Serial: HNP-11-034  
10 CFR 50, App H

SHEARON HARRIS NUCLEAR POWER PLANT, UNIT NO. 1  
DOCKET NO. 50-400/RENEWED LICENSE NO. NPF-63  
REVISION TO REACTOR VESSEL SURVEILLANCE CAPSULE  
WITHDRAWAL SCHEDULE

SHEARON HARRIS NUCLEAR POWER PLANT, UNIT NO. 1  
DOCKET NO. 50-400/RENEWED LICENSE NO. NPF-63  
REVISION TO REACTOR VESSEL SURVEILLANCE CAPSULE  
WITHDRAWAL SCHEDULE

Attachment 1. HNP RPV Surveillance Capsule Orientation

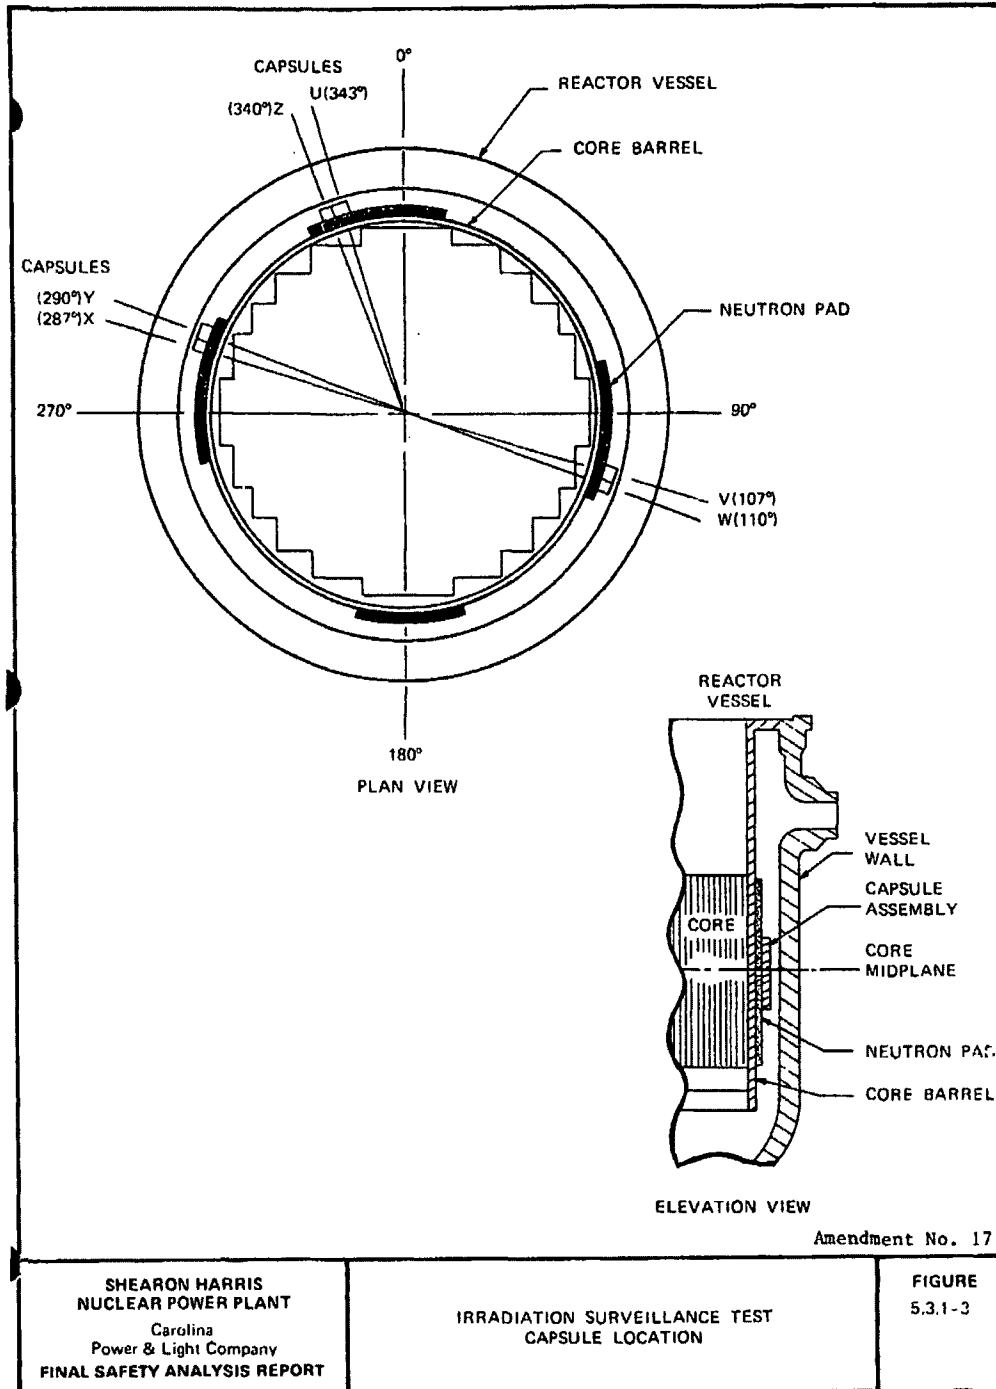
As a replacement to fulfill the commitment to test Capsule W, HNP proposes to withdraw Capsule Y or Z during RFO-21, at which time the Capsule Y or Z is estimated to have reached the projected 80-year, 73 Effective Full Power Years (EFPY), peak RPV fluence of

approximately  $9.15\text{E}+19$  n/cm<sup>2</sup>. At the end of Cycle 21, the capsule will have received an estimated fluence of  $9.39\text{E}+19$  n/cm<sup>2</sup>. The capsule contents will be tested and analyzed in accordance with ASTM E185-82 and Appendix H to 10 CFR 50. The remaining capsule will serve as a standby capsule. Since Capsule Y, at the 290° location, and Capsule Z, at the 340° location, have identical capsule contents, receive approximately equal fluence, and have the same lead factor, either of the two may be withdrawn during RFO-21. This proposed change meets the requirements of Appendix H to 10 CFR Part 50. The proposed capsule withdrawal schedule is shown in Table 2.
